**ADDENDUM TO PREFERRED PROJECT REPORT (DECEMBER 2009)  
MAJOR PROJECT APPLICATION NO. 08\_0034**

**PROPOSED SUBDIVISION AT LOTS 2 AND 3 DP 244652  
URLIUP ROAD BILAMBIL  
(TWEED LOCAL GOVERNMENT AREA)**

**MARCH 2010**

Scale 1 : 1500	Level Datum —	Drawn MES	Chk'd —	F.Bk —	L.Bk —
REF. No. T15337	Date 31/07/08	Drawing No./Size 17154 D	Rev. G

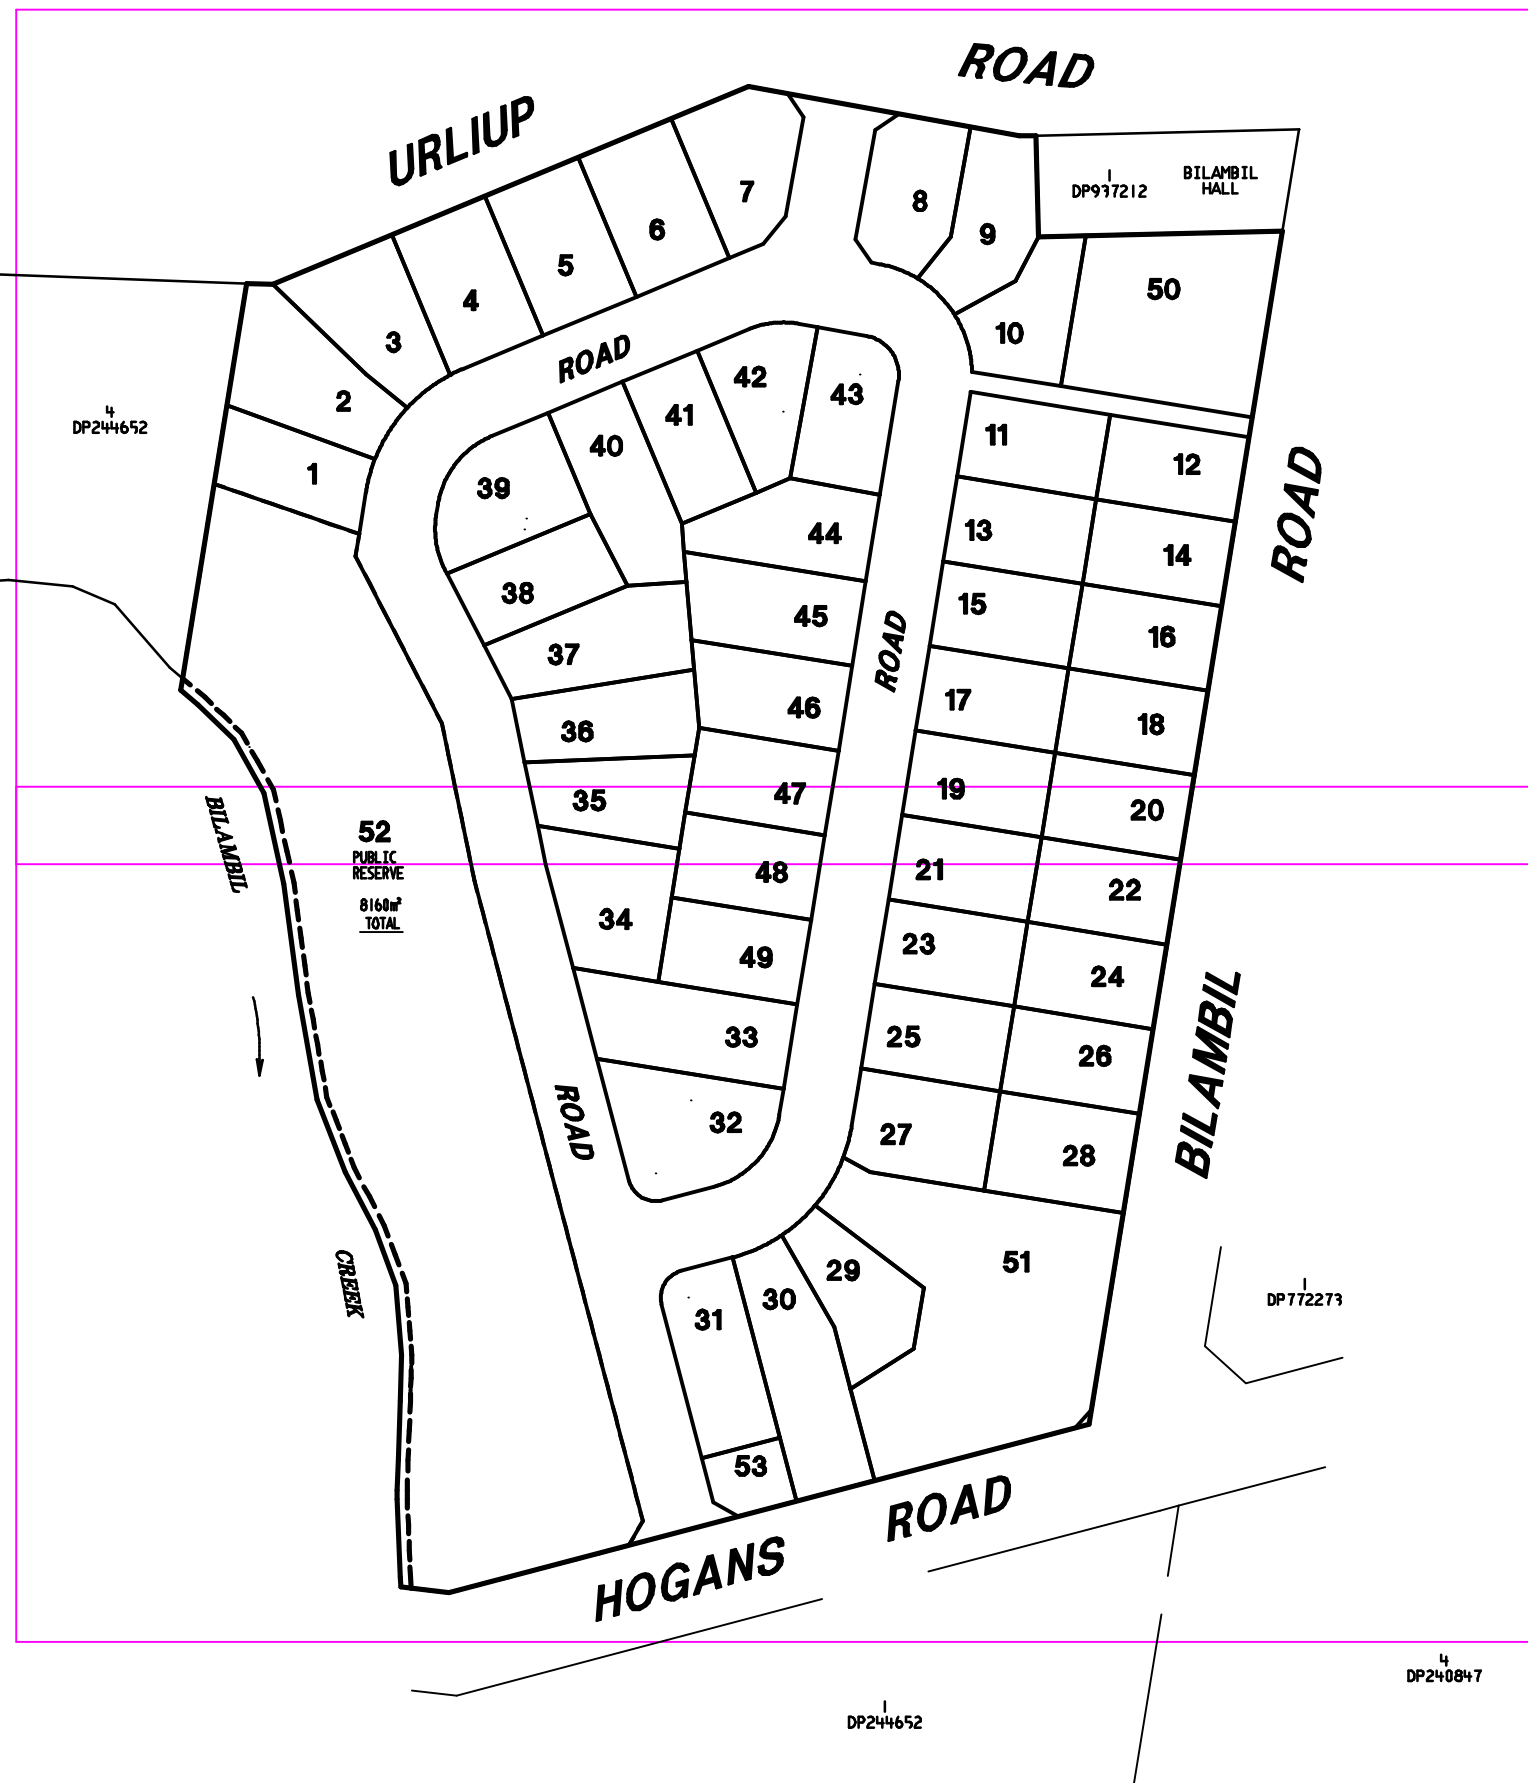
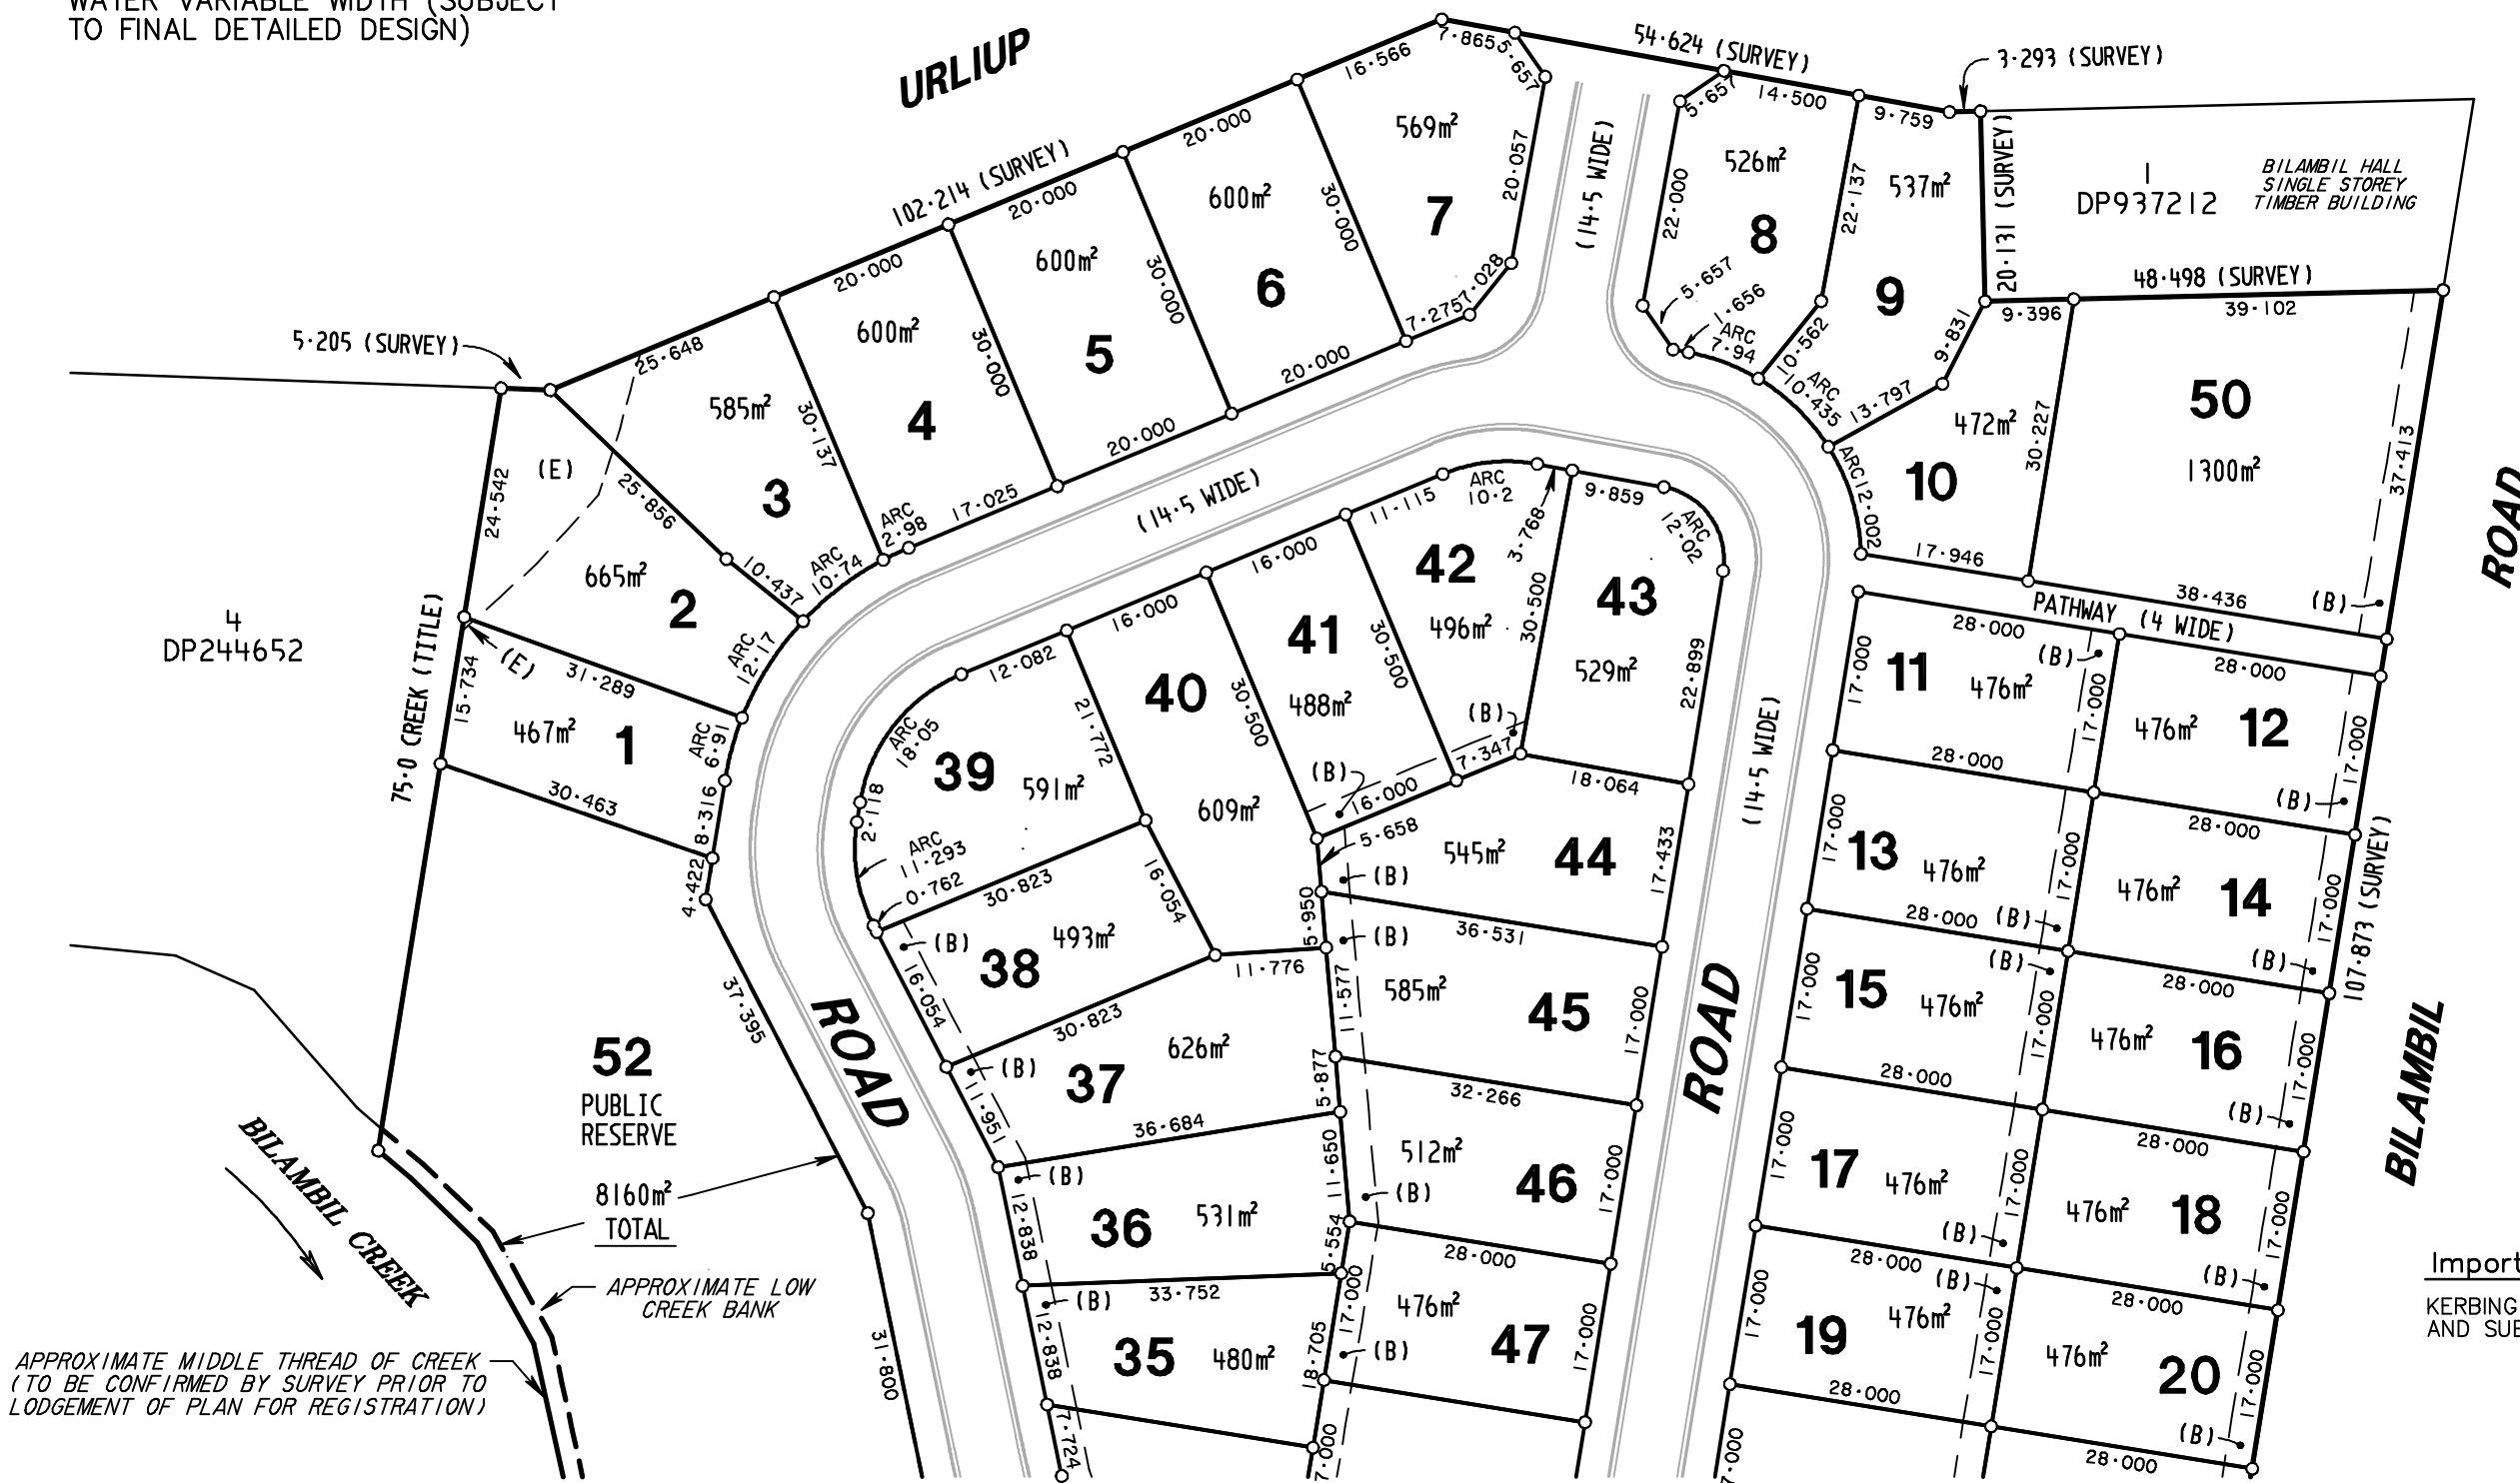
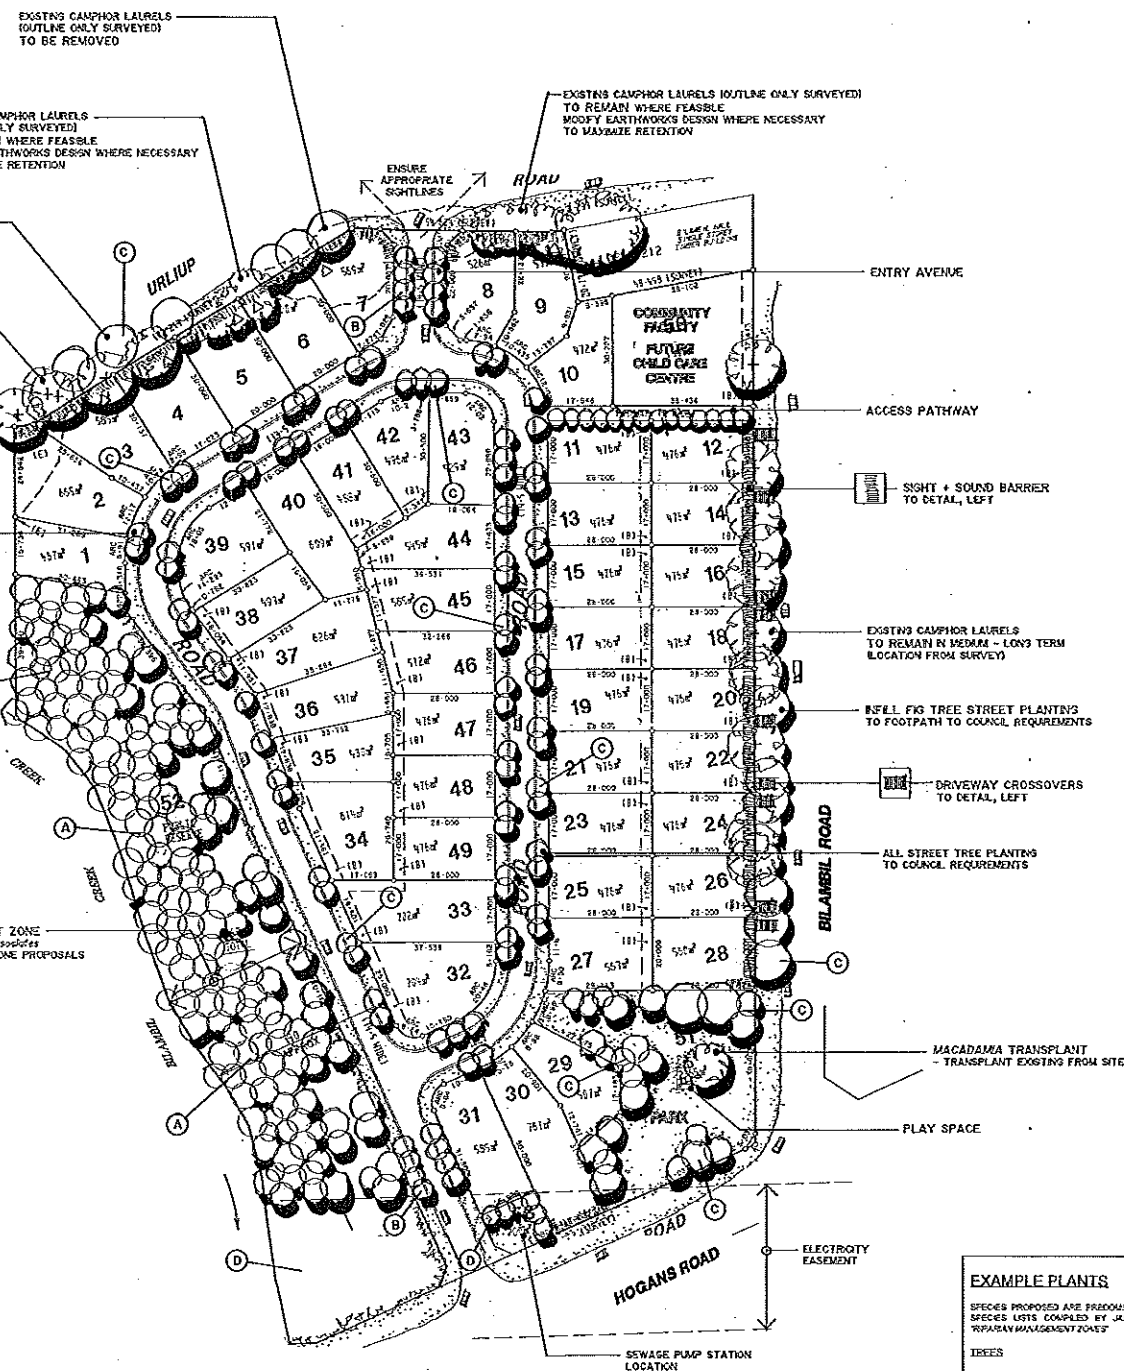
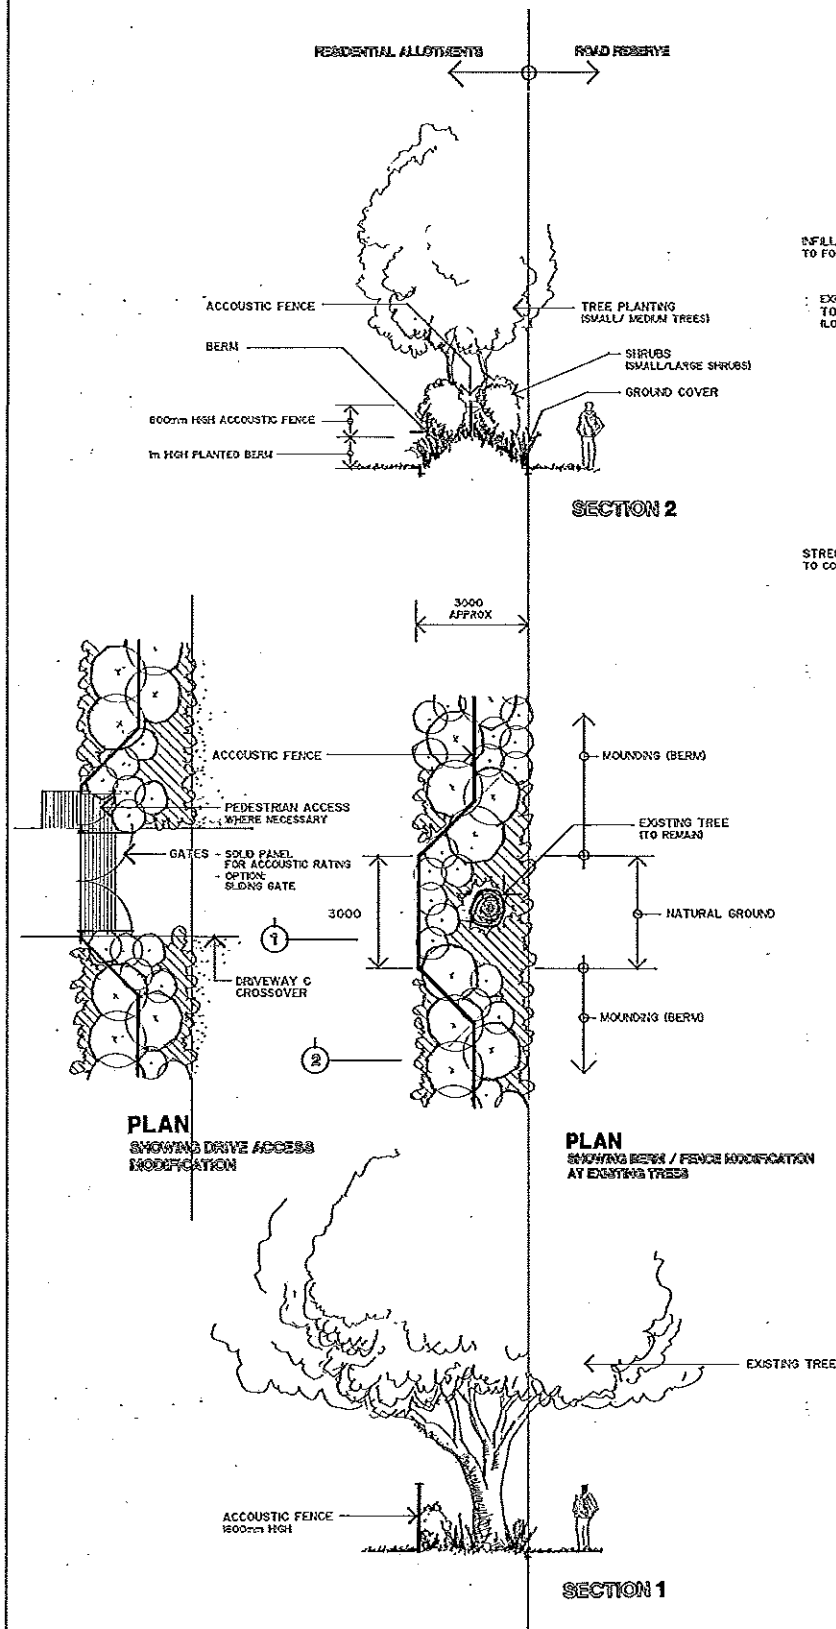
Following negotiations between Mr Tom Fitzgerald of the Department of Planning and Tweed Shire Council Officers, Council's Traffic Engineer has raised no objections to Lots 12, 14, 16, 18, 20, 22, 24, 26 and 28 having direct vehicular access to Bilambil Road (see email from Tom Fitzgerald to John Sherwood dated 9 February 2010).

The Plan deletes the previously proposed rights of carriageway/easements to the internal road to service those lots adjacent to Bilambil Road.

Deletion of the access easements over the lots fronting the internal street will reduce traffic volumes by approximately 90 vehicles per day on that street, reduce the number of driveway penetrations (by 9) and result in improved residential amenity and streetscape by enabling additional street plantings.

Provision of direct vehicular access to those lots from Bilambil Road leads to a better planning outcome by deleting the access easements and creating a larger usable area for each burdened lot.
